SUBJECT: SUMMARY OF DECEMBER 16, 1999, MEETING WITH BNFL
FUEL SOLUTIONS AND CONSUMERS ENERGY

Meeting between Nuclear Regulatory Commission
and BNFL Fuel Solutions

Talking Points for Clarification on Cladding Temperature Limit and High Burnup Fuel Analyses

Comparison of Spilker Time Exponent with FRG-2 Unirradiated and Irradiated Creep Strain Data

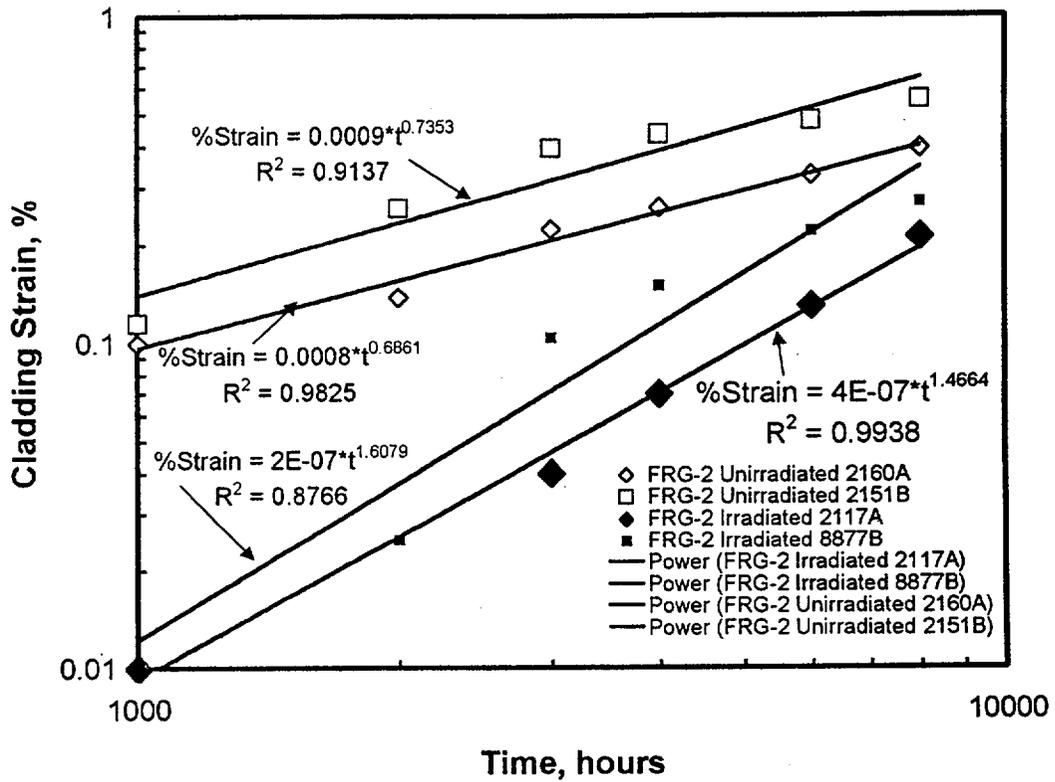
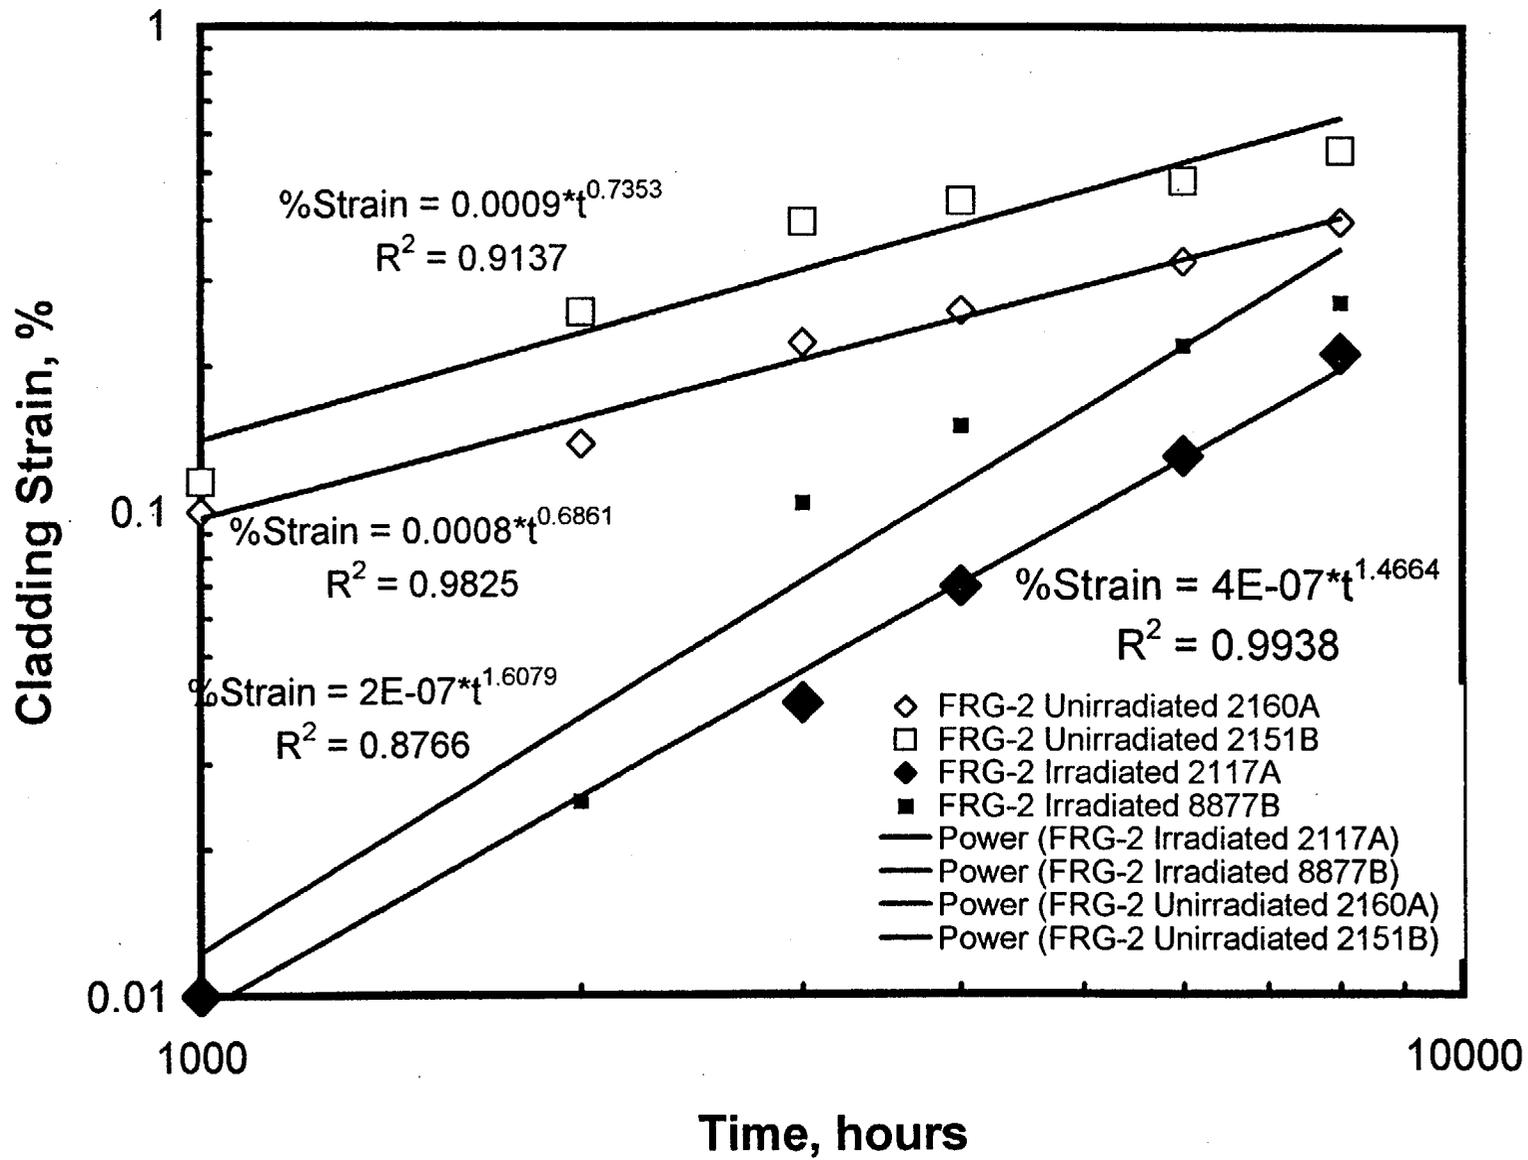
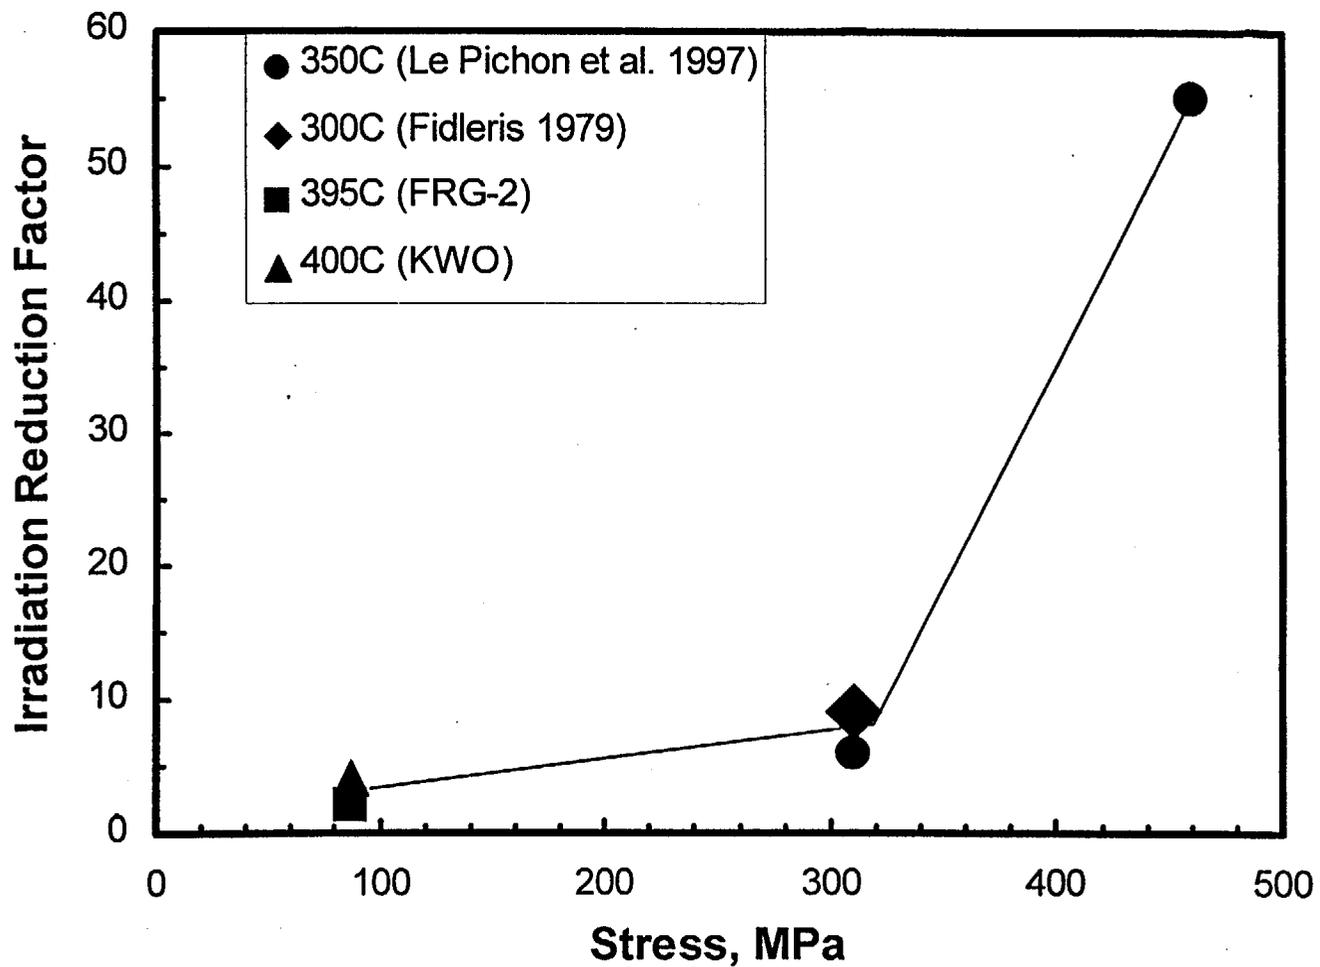
4. The factor of 10 between the Spilker equation for unirradiated Zry-4 and the irradiated FRG-2 creep data does not appear to be defensible. The difference between the unirradiated FRG-2 (WCAP-15168, Figure 4-2) and the irradiated (WCAP-15168, Figure 4-4) creep data are shown to range from a factor of 1.4 to a factor of 2.5 for a stress of ~87 MPa and 395°C. Examination of other published data show the ratio of unirradiated to irradiated creep to be strongly stress dependent. The values of the creep reduction factor (of unirradiated to irradiated creep) in the Schaeffler-LePichon et al. 1997 work decrease from ~55 at 460 MPa to ~6 at 310 MPa at 350°C. Further, the value at 300°C and 310 MPa is ~9 (Fidleris 1979 ASTM STP 681).

The following figure compares the strain-time curves for the two bounding unirradiated FRG-2 test series from Figure 4-2 on Page 4-17 with the strain-time curves for the two bounding irradiated FRG-2 test series from Figure 4-4 on Page 4-19. The data are presented on log-log plots which is the format used by Spilker to evaluate the value of the time exponent from the slope.

The results show consistency in the values of the exponents on time for the unirradiated FRG-2 tests with the Spilker-equation approach in that the values of the time exponents are <1 ($m < 1$). However, for the irradiated FRG-2 data, the time dependence does not follow the Spilker equation. The values of the time exponents are >1 ($m > 1$). Consequently it appears that extrapolation of these data on the Spilker type correlation plot results in the creep strain curves for irradiated Zry-4 crossing over and above the creep strains for unirradiated Zry-4 in less than 20,000 hours under isothermal conditions. Extrapolation of the irradiated FRG-2 data on this plot suggests that the 1% strain limit might be reached in less than 20,000 hours under isothermal conditions.
